## CERTIFICATE OF APPROPRIATENESS

**Property:** 2206 Lubbock Street, Lot 5, Block 395, Baker W R NSBB Neighborhood Subdivision. The property includes a historic 1,384 square foot, one-story wood single-family residence and detached garage situated on a 5,000 square foot (50' x 100') interior lot.

**Proposal:** Alteration: Front Façade, Windows, Siding, and Rear Addition

Existing smooth, beveled siding that remains on front, right elevation

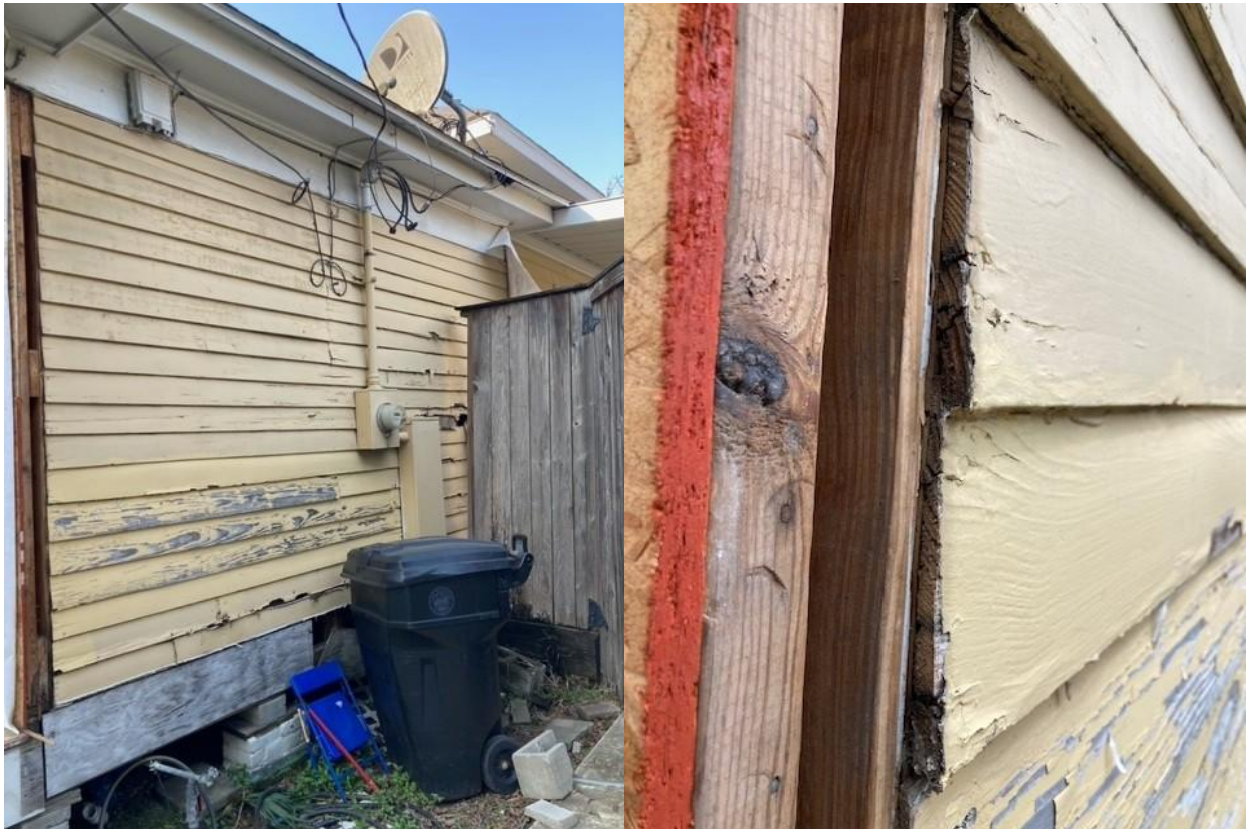
S	D	NA		S - satisfies	D - does not satisfy	NA - not applicable
<input type="checkbox"/>	<input checked="" type="checkbox"/>	<input type="checkbox"/>	(1)	The proposed activity must retain and preserve the historical character of the property; <b>textured siding and flush mounted windows does not preserve the historical character of the property.</b>		
<input checked="" type="checkbox"/>	<input type="checkbox"/>	<input type="checkbox"/>	(2)	The proposed activity must contribute to the continued availability of the property for a contemporary use;		
<input type="checkbox"/>	<input checked="" type="checkbox"/>	<input type="checkbox"/>	(3)	The proposed activity must recognize the building, structure, object or site as a product of its own time and avoid alterations that seek to create an earlier or later appearance; <b>textured siding and flush mounted windows does not recognize the building as a product of its own time. Rather it creates a later appearance akin to the big white houses being built across America in the 2020s.</b>

<input type="checkbox"/>	<input checked="" type="checkbox"/>	<input type="checkbox"/>	(4)	The proposed activity must preserve the distinguishing qualities or character of the building, structure, object or site and its environment; <b>textured siding and flush mounted windows does not preserve the historical character of the building.</b>		
<input type="checkbox"/>	<input checked="" type="checkbox"/>	<input type="checkbox"/>	(5)	The proposed activity must maintain or replicate distinctive stylistic exterior features or examples of skilled craftsmanship that characterize the building, structure, object or site; <b>textured siding and flush mounted windows does not maintain the stylistic exterior features that characterize the building.</b>		
<input type="checkbox"/>	<input checked="" type="checkbox"/>	<input type="checkbox"/>	(6)	New materials to be used for any exterior feature excluding what is visible from public alleys must be visually compatible with, but not necessarily the same as, the materials being replaced in form, design, texture, dimension and scale; <b>textured siding and flush mounted windows are not visually compatible with the materials typical in the Old Sixth Ward Historic District.</b>

**Recommendation:** Denial of COA and Issuance of COR to replace textured siding with smooth, beveled siding with a 5" reveal on front, left, and right elevations; add a sill to window trim on all windows; inset and recess already installed windows; and approved as submitted for all other proposed work.

Non-Historic Windows Removed

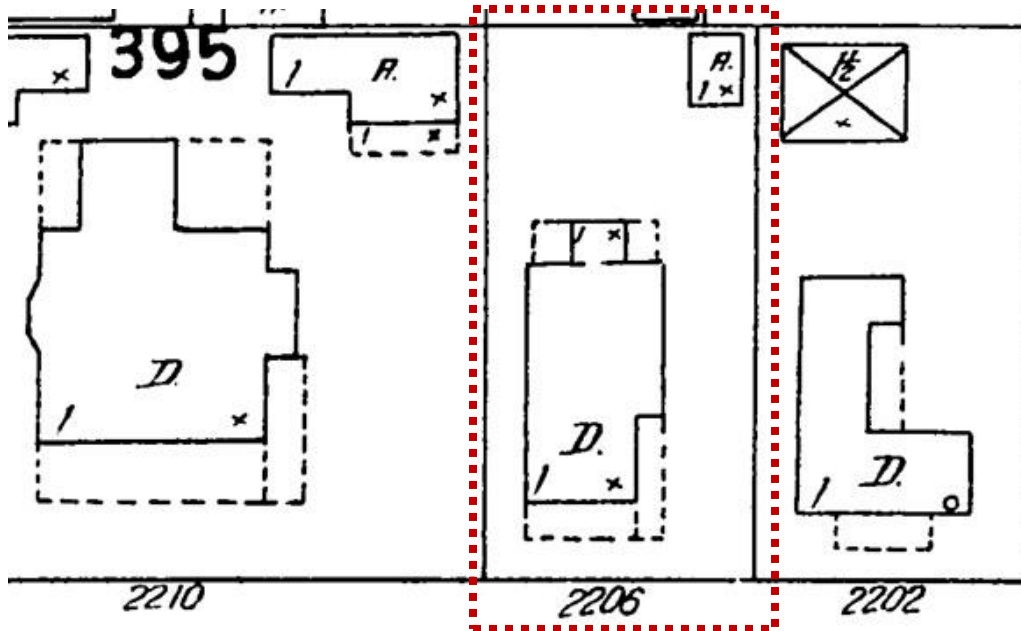
- Removal of existing non-historic windows and replaced with flush mounted, SH, 1-over-1 windows
- Removal of smooth, beveled siding and replaced with textured siding
